DEFECTIVE OR INCOMPLETE DISPLAY ON LCDA SCREEN

Products concerned: Top Malice Evolution and Maxitop machines with LCDA screen (E3)

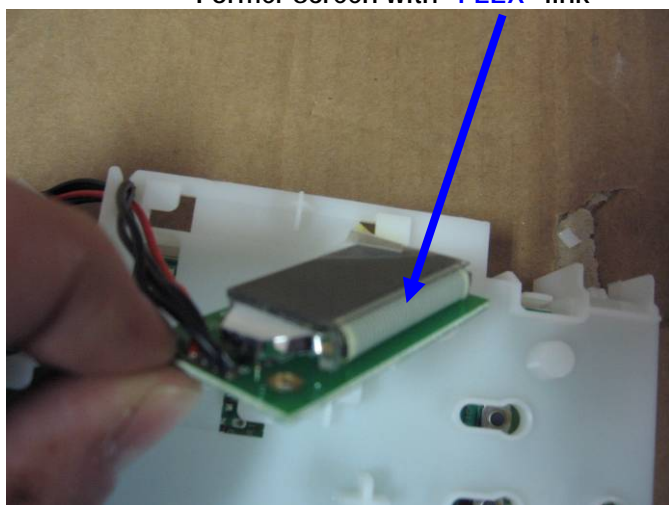
Description of the problem: Faulty or incomplete display on the screen

Source of the problem: Weakness in the link between the flex (28 wires) and the screen.

Factory action: Removal of the "flex" link and replacement by direct 28 metal pin connection between the screen and the printed circuit board.

Former screen with "FLEX" link

New screen with "METAL PIN" link

ASS action or solution: This new screen is available as a spare part under reference AS0000284, to avoid having to exchange the circuit board.
